Timor / Isis River Community Presentation

Independent Planning Commission
Hills of Gold Wind Farm (HOG Wind Farm)
February 2024

Proposed Hills of Gold Wind Farm UHSC DCP Breaches updated post amended Report 22022

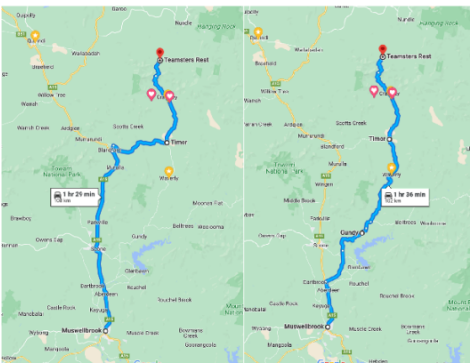
Contractors from the South will obviously travel via Gundy and Timor to save time and km!!

HOG Farm Access
 Route: Via Blandford and Timor
 Distance: 108 km
 Time: 1 Hr 29 mins

HOG Farm Access
 Route: Via Gundy and Timor
 Distance: 102 km
 Time: 1 Hr 36 mins

Pages Creek Fire – Dec 2019 – Looking up Perry's Creek towards the Wind Farm Project Area (WTG 18 - 25)

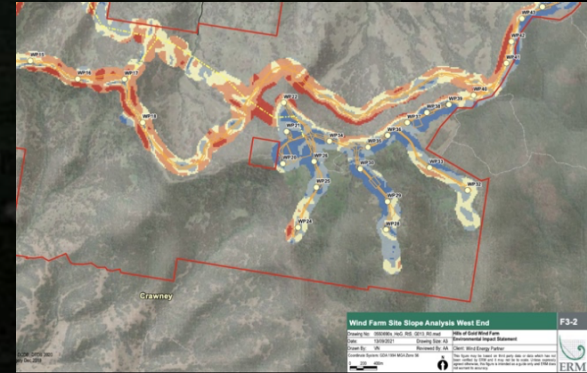
WTGs 2,7,8,14,15,16,17,18,20,22,24,28,29,32,33 - All on the Precipice

**UNSUITABLE LOCATION =
UNACCEPTABLE RISK**
